Meadowvale Heritage Conservation District Advisory Sub-Committee

1. Request to Alter 7004 Second Line West
Memorandum dated May 27, 2016 from Paula Wubbenhorst, Senior Heritage Coordinator, Culture Division. (*Note: Appendix 1 available online*)

Subject: Request to Alter 7004 Second Line West

HERITAGE IMPACT STUDY
IMPACT OF PROPOSED RENOVATION
7004 SECOND LINE W., MISSISSAUGA

CHUNG RESIDENCE
FRONT ELEVATION $\frac{3}{32}$ " - 1'0"
7004 SECOND LINE WEST, MISSISSAUGA
MARCH 15, 2016

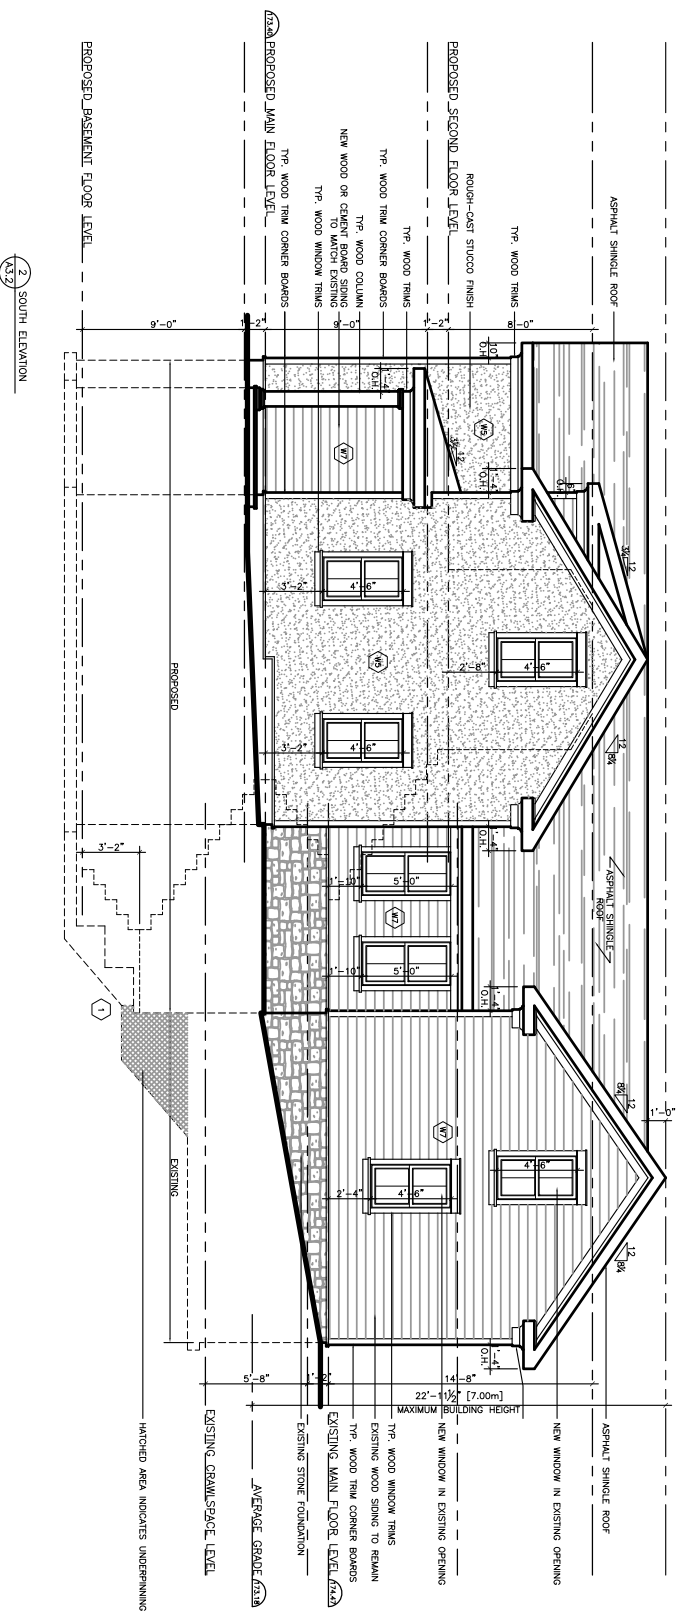
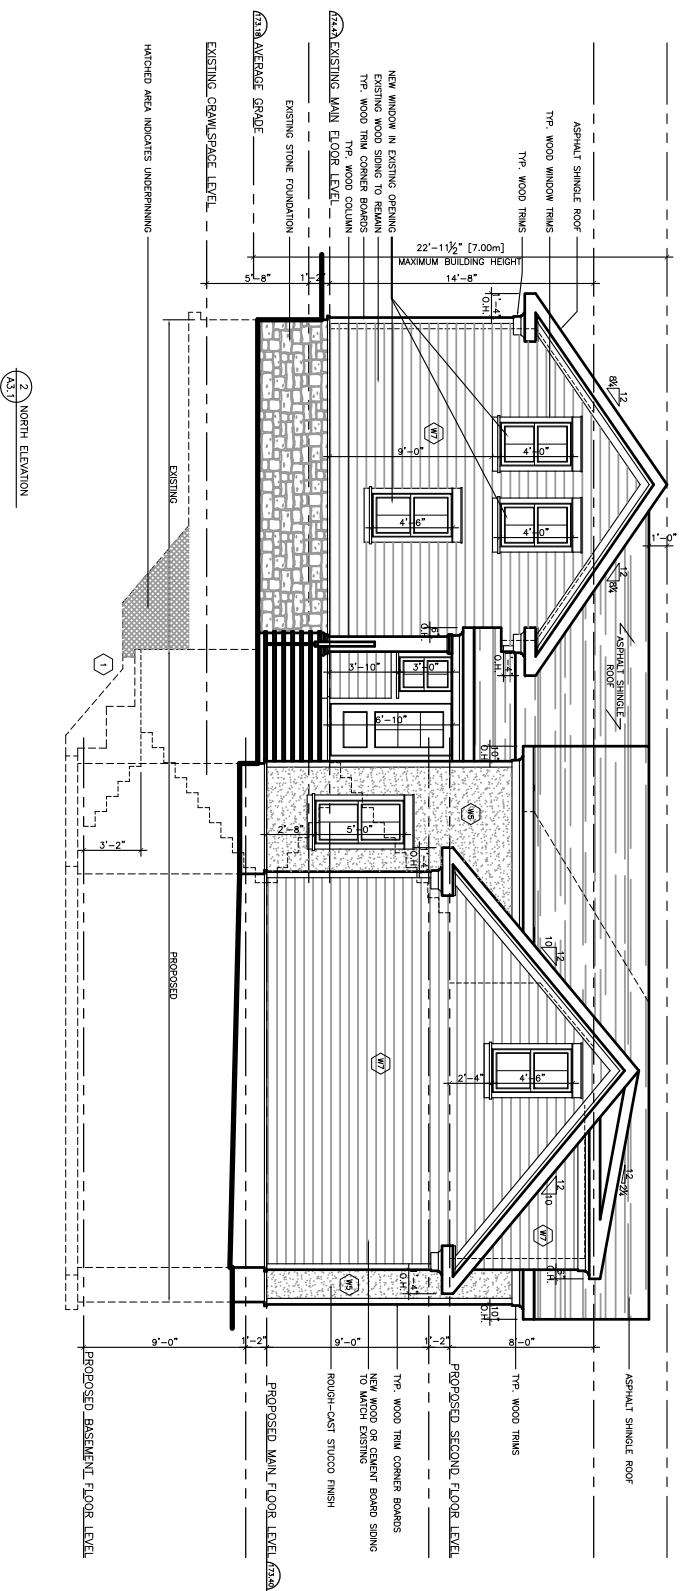
The proposal is a two storey addition at the northwest of the existing dwelling. While two storeys in height, the dip in the natural topography would make it appear lower. A more recent addition to the existing board on board dwelling would be removed. The proposed addition would be largely clad in rough-cast stucco with some elements clad in new

10. Maintain primary entrance in original location	No additional doors are proposed for the front façade. The proposed replacement door should be further simplified to be more consistent with the period of the existing dwelling.

13. Repair and retain original windows	No original windows exist. The windows would be replaced with double hung windows. Simulated divided lites are proposed. As per the guidelines, "simulated dividers [...] should not be used."

- No simulated dividers be employed on the windows
- The proposed replacement door be simplified
- Any repairs made to the original siding match the original material and dimensions

1 WEST ELEVATION
 SCALE: 1/4"=1'-0"

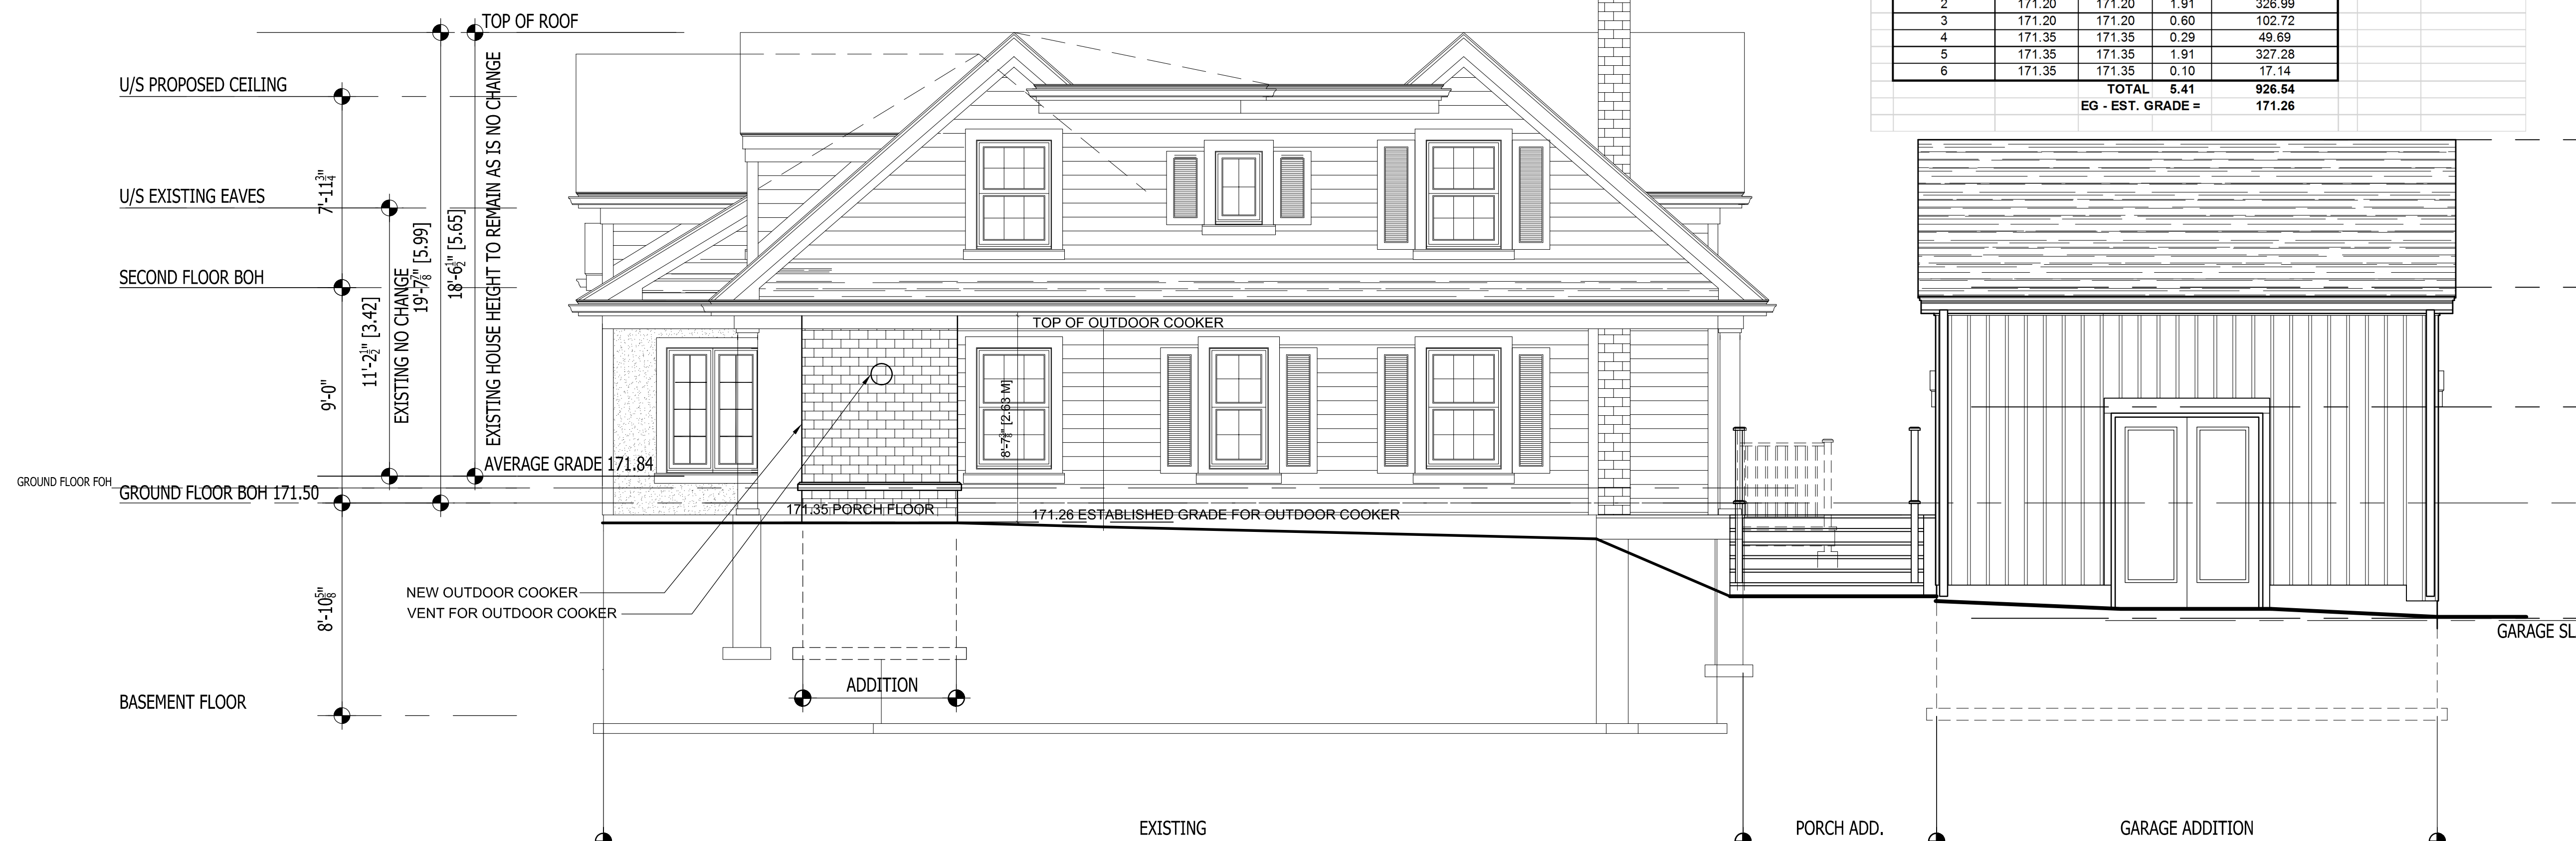
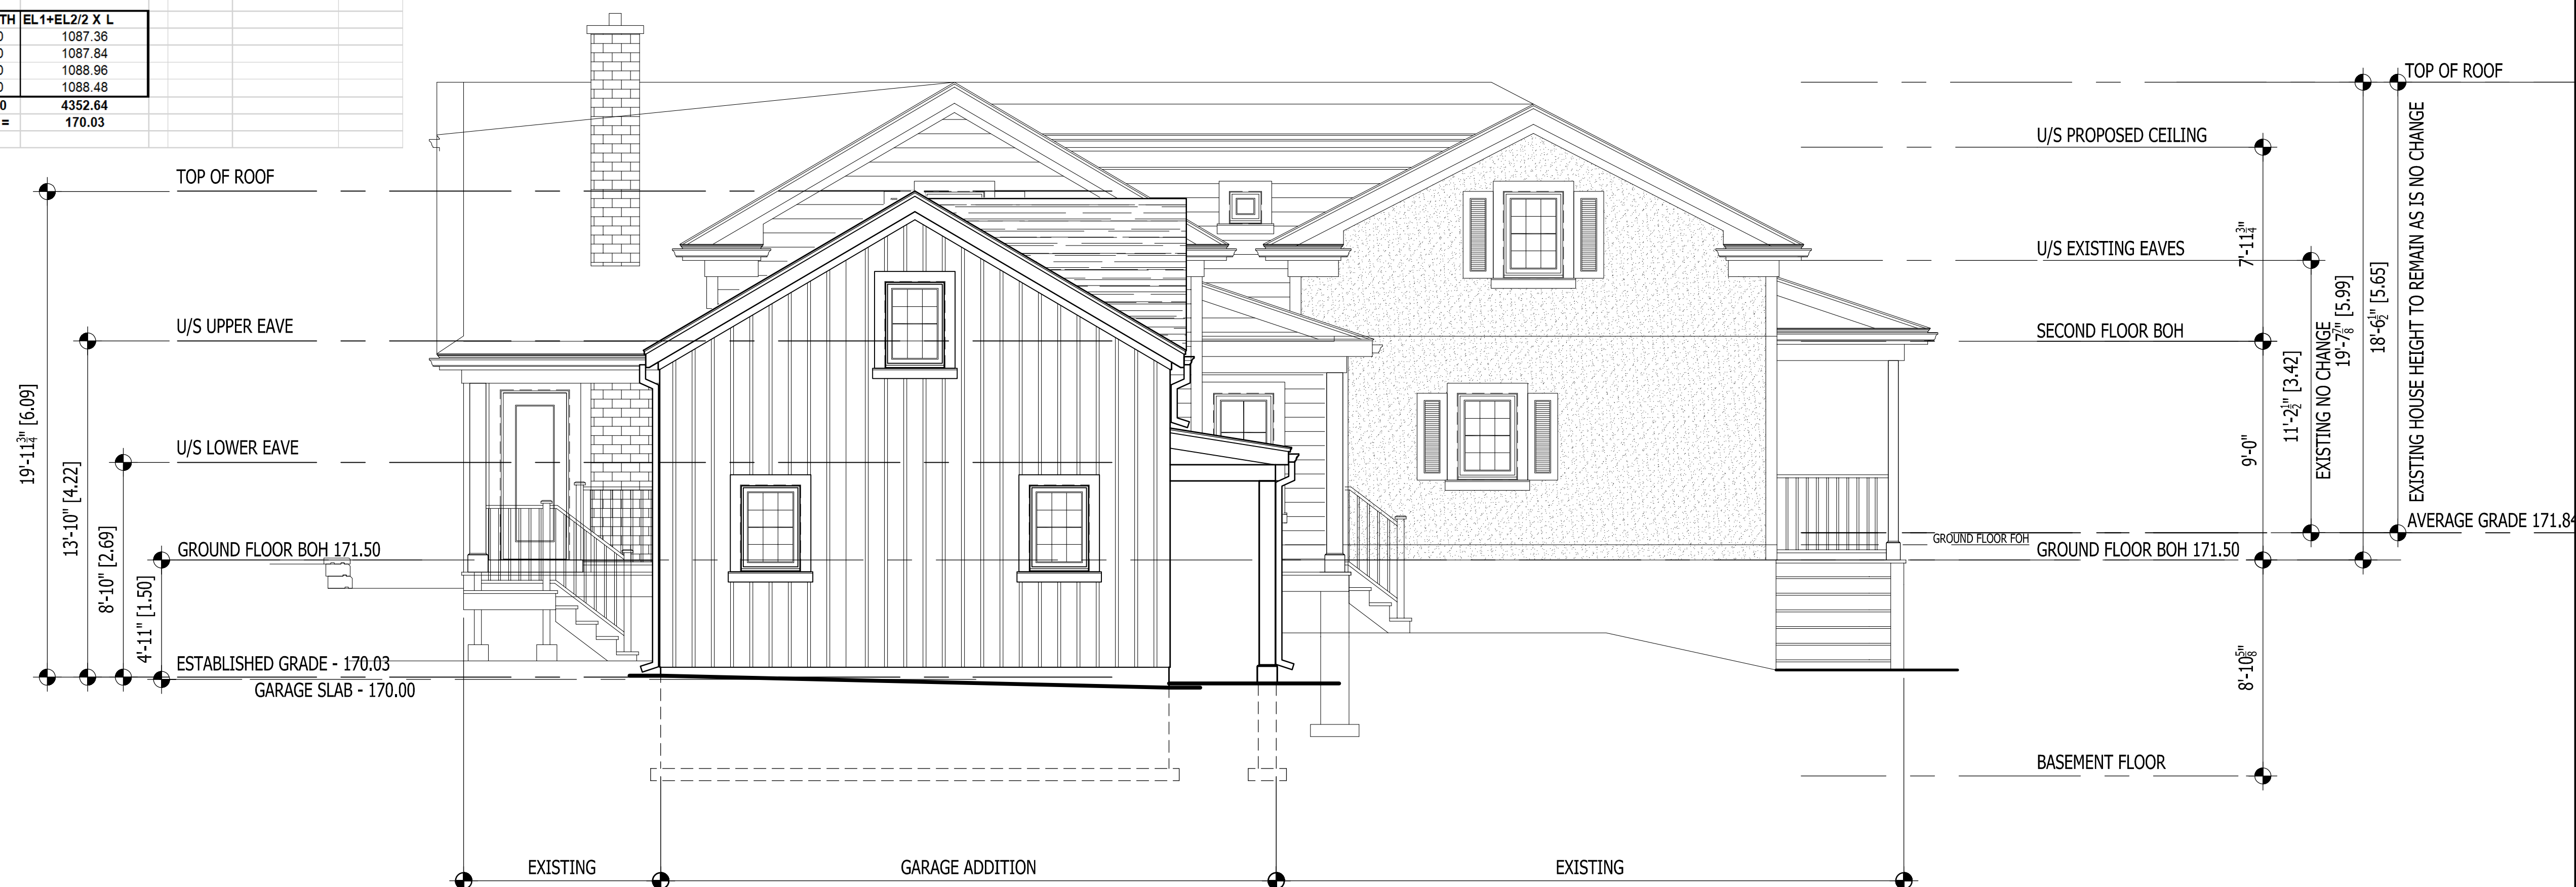
There has been no change to the proposal. However, additional elevations have been provided since the permit was evaluated in 2014. The drawings do not indicate the detail of the window configuration. As per the 2003 Meadowvale Village Design Guidelines, "simulated dividers [...] should not be used."

- No simulated dividers be employed on the windows

DRAWING : LAYOUT 2

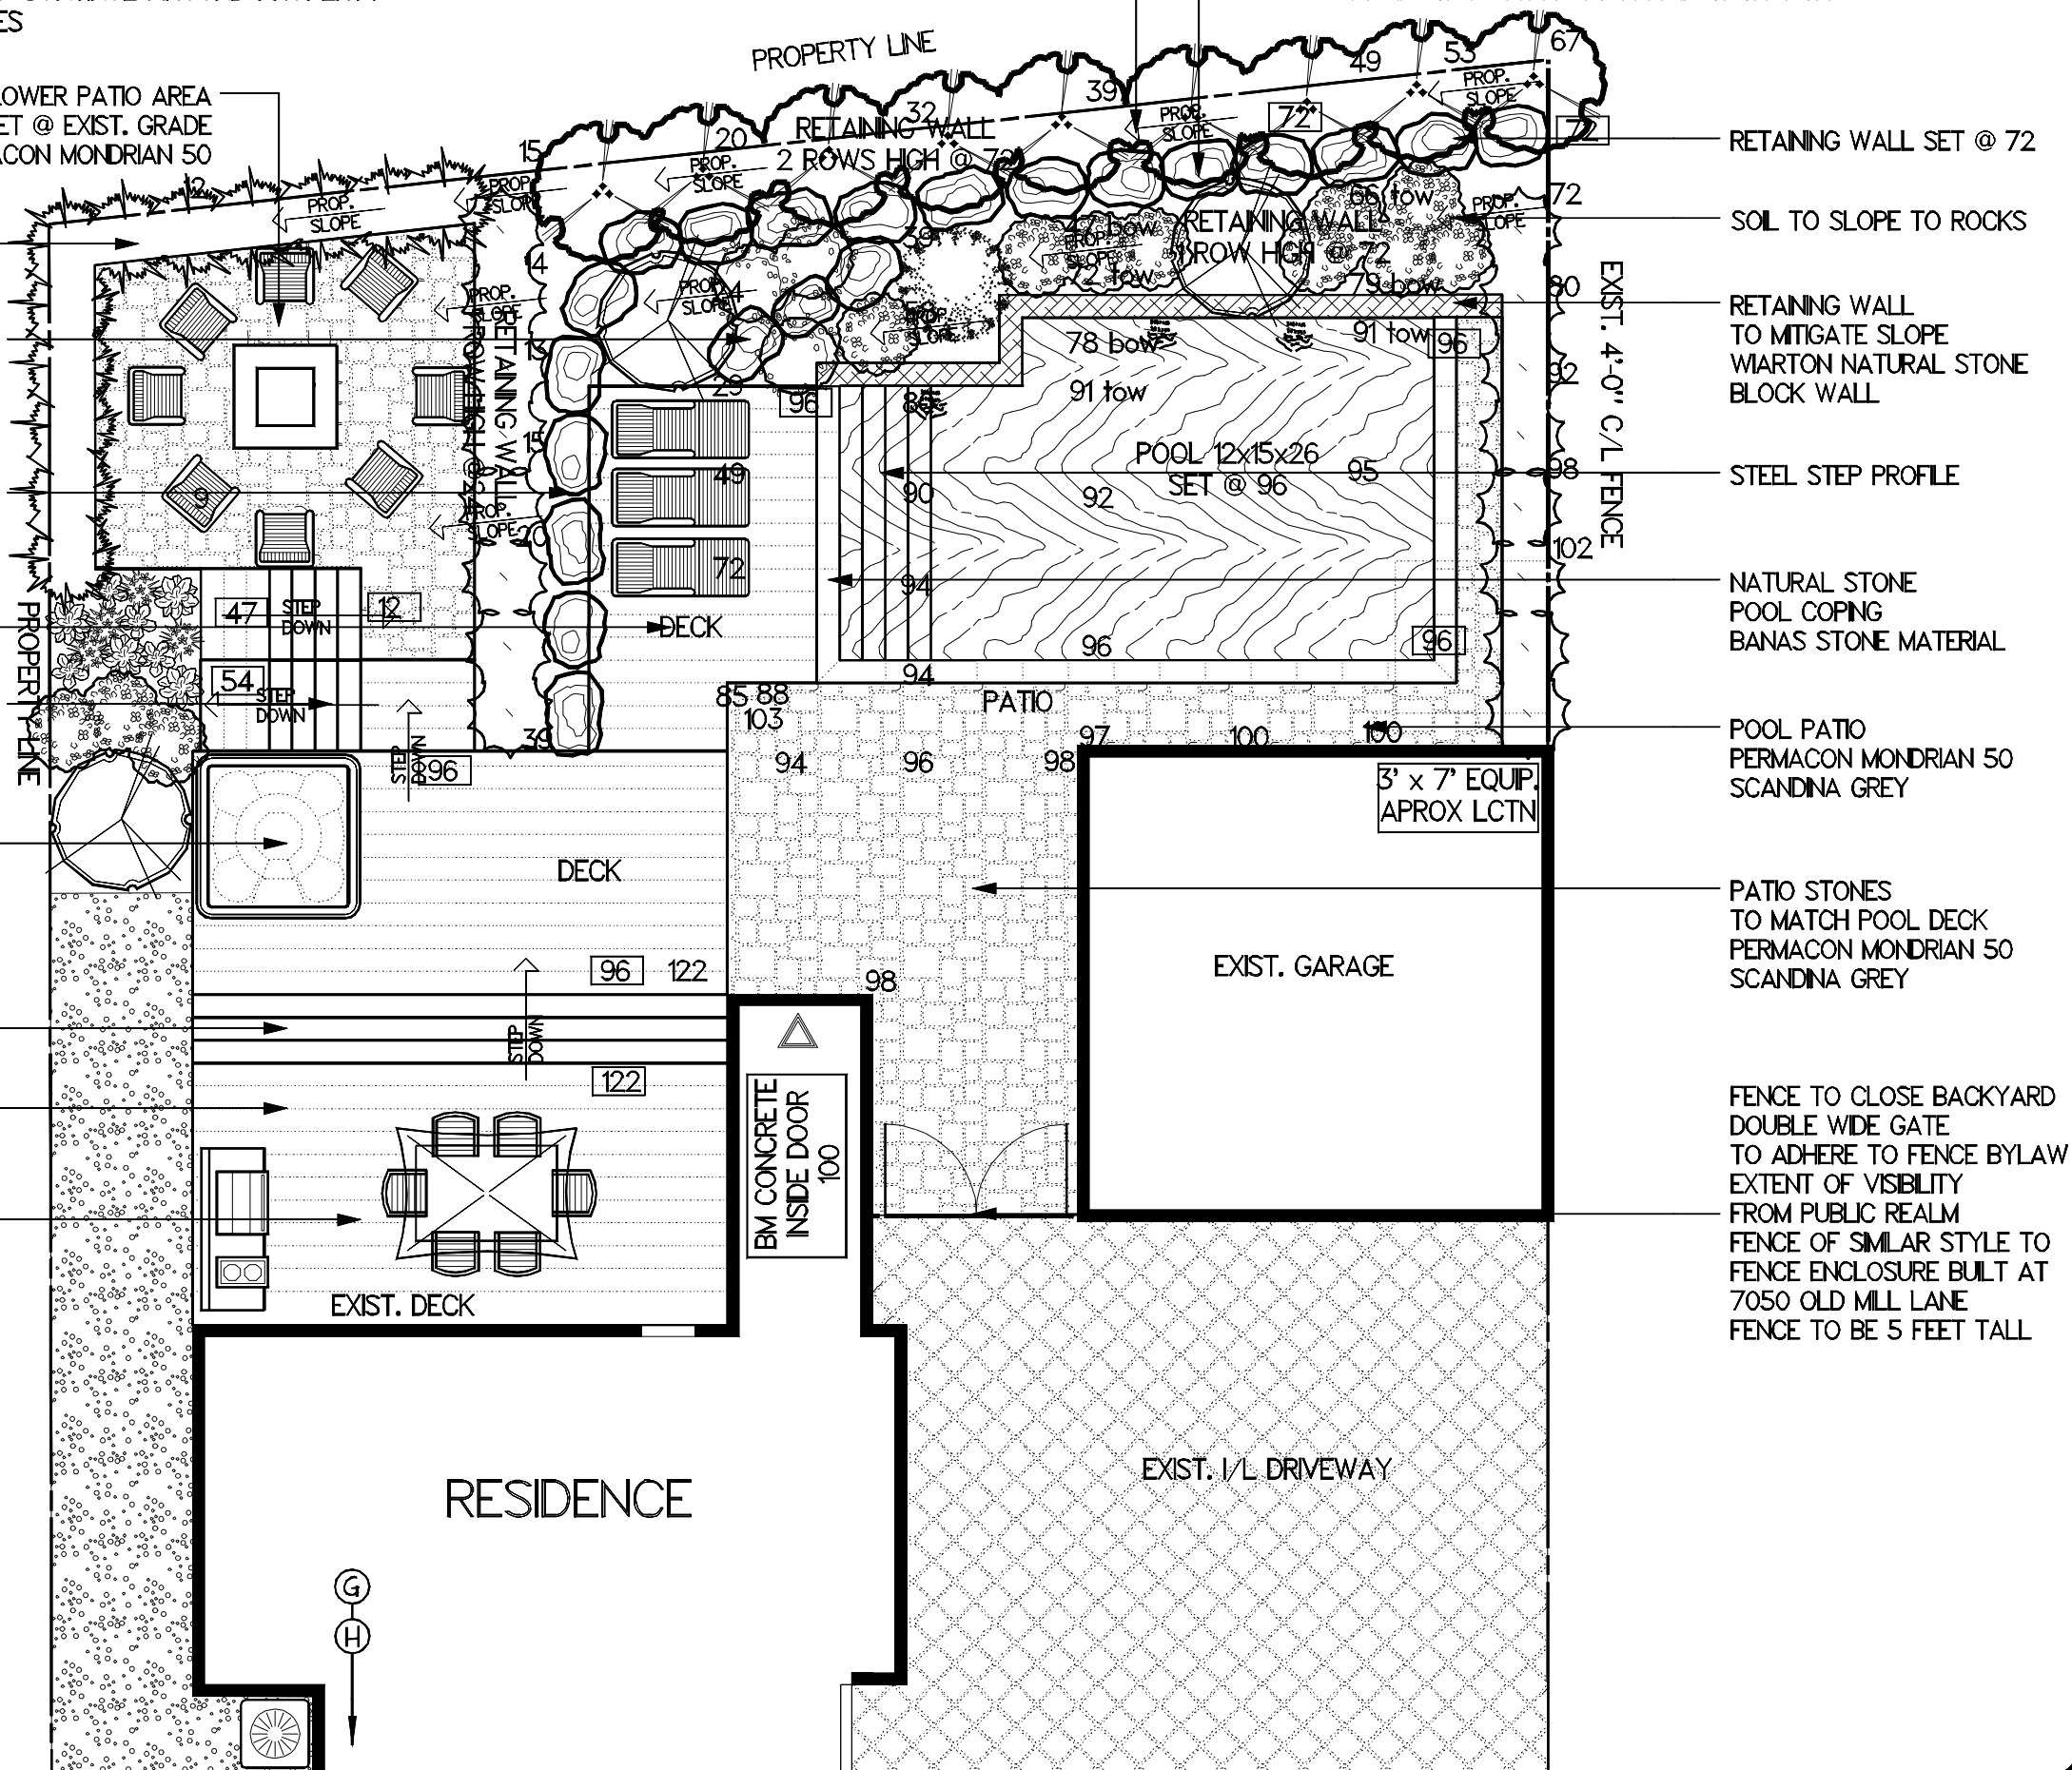
Overall, the main concern is the armour stone retaining wall. It is not compatible with the character of the neighbourhood. While plantings and fencing may minimize the appearance at some point in time, it will take time for plantings to have the desired camouflaging effect. Additionally, plantings and fencing are easily reversed. They may be removed by a future owner, exposing the large wall.

For all of the above stated reasons, Heritage Planning staff recommend that the proposed changes not be approved.
